Responses to Comments

Fenton Parkway Bridge Project

STATE CLEARINGHOUSE NO. 2023050534

SEPTEMBER 2024

Exhibit A-4-2. Caltrans District 11 Right-of-Way Map
Source: Caltrans 2024.

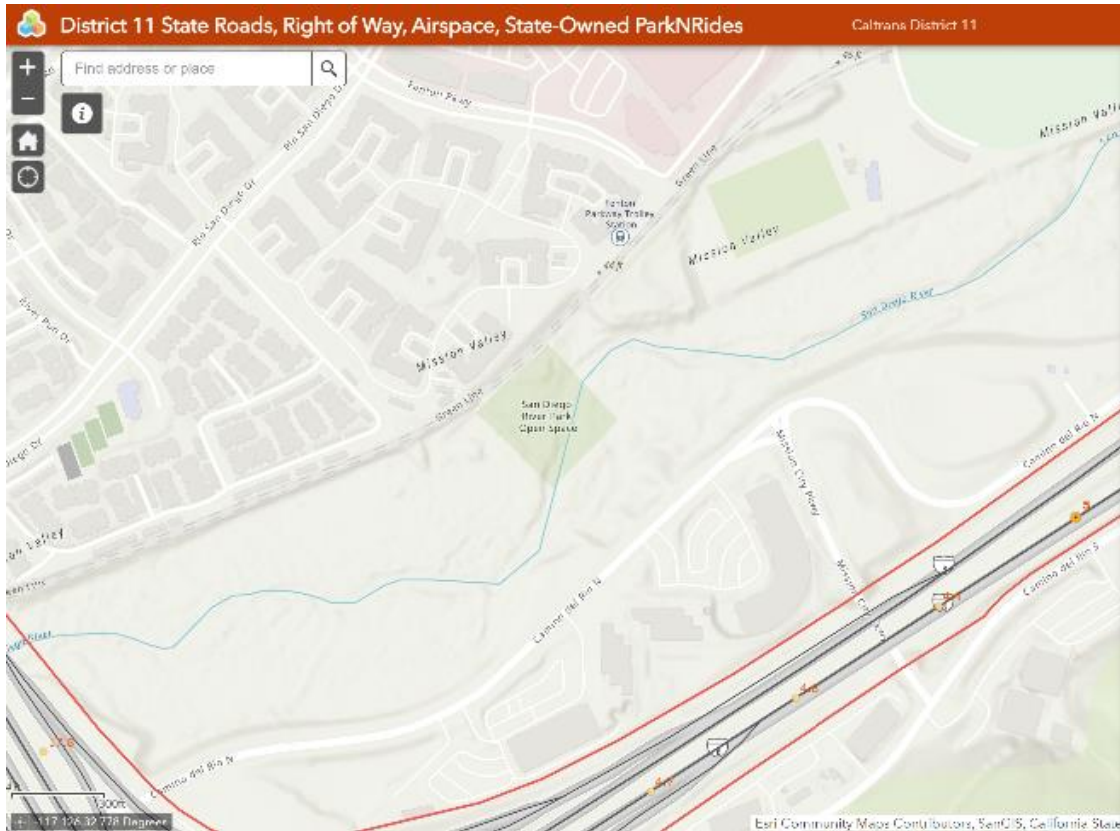
A-4-18 The comment states that Caltrans is a Responsible Agency under CEQA as they have some discretionary authority over a portion of the project that is in Caltrans' right-of-way in the form of an encroachment permit process. A review of online Caltrans right-of-way maps (see Exhibit A-4-2) shows that the proposed project's physical limits do not encroach into any Caltrans-maintained property. To better understand this comment, a virtual meeting was held on July 1, 2024, with Caltrans staff and project team representatives. The list of attendees included the following:

During this meeting, Caltrans staff clarified that the project may result in changes to hydrology in the San Diego River that may impact other structures in Caltrans right-of-way (ROW) such as the I-805 freeway ramp columns located west of the Fenton Parkway Bridge alignment. To ensure that Caltrans had all of the applicable studies related to traffic and circulation, Fehr & Peers submitted a copy of the January 2020 transportation impact analysis (TIA) report for the San Diego State University Mission Valley Campus to Caltrans after the above-referenced meeting via email on July 1, 2024. The TIA included an analysis of future traffic conditions with and without the planned Fenton Parkway Bridge with buildout of the proposed Mission Valley Campus.

Exhibit A-5-1. Public Storm Drain Plan.

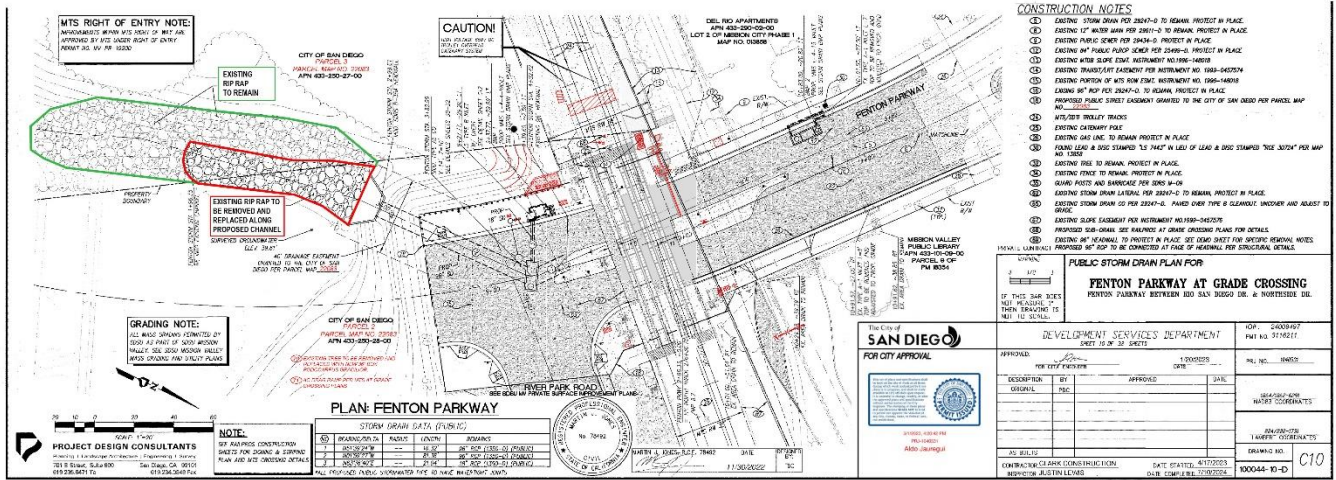
A-5-37 This comment speaks to a concern about unauthorized impacts to the Fenton Parkway Drainage that occurred during development of the Snapdragon Stadium and/or Mission Valley River Park. The area in question is shown in EIR Figures 3.3-4 – View 1 through 3.3-4 – View 4, specifically the polygons that are titled “Prior Permit Area.” These prior impact areas entailed removal of riparian vegetation and reorientation of existing riprap associated with the unnamed stormwater drainage that daylight at the southern terminus of Fenton Parkway. During final design of River Park Road and the Mission Valley River Park, it was determined that these modifications to this drainage were necessary. The CSU pursued an Informal Section 7 Consultation for this work with USFWS (FWS-SDG-2022-0028183, issued June 30, 2022). This impact was implemented in accordance with the June 30, 2022, Informal Section 7 Consultation; specifically the impact areas allowed by this permit are depicted in Figure 2, Headwall and Riprap Pad, and Figure 3, Fenton Parkway Culvert Extension, of the June 30, 2022, Informal Section 7 Consultation. The polygons that are shown as “Prior Permit Area” in Figures 3.3-4 – View 1 through 3.3-4 – View 4 of the Draft Fenton Parkway EIR match the polygons shown in Figures 2 and 3 in the June 30, 2022, Informal Section 7 Consultation. The work outlined in this Informal Section 7 Consultation was completed in March 2024 and, as required by Conservation Measure 4g of the Section 7 consultation letter, a final permit compliance report was prepared and submitted to the USFWS (David Zoutendyk) on May 21, 2024.

In reviewing the May 21, 2024, final environmental compliance report, it appears that the graphic titled Landscape Construction Plans for the Mission Valley River Park Improvements – Base Scope (page 15 of page 37) shows the “as-builts” of the riprap in this unnamed drainage without differentiating between existing riprap and relocated riprap (Dudek 2024). Exhibit A-5-1 is provided to differentiate between the riprap that was previously located in this drainage that was not modified (outlined by the green polygon) and the riprap that was relocated as part of the Fenton Parkway extension (outlined by the red polygon).
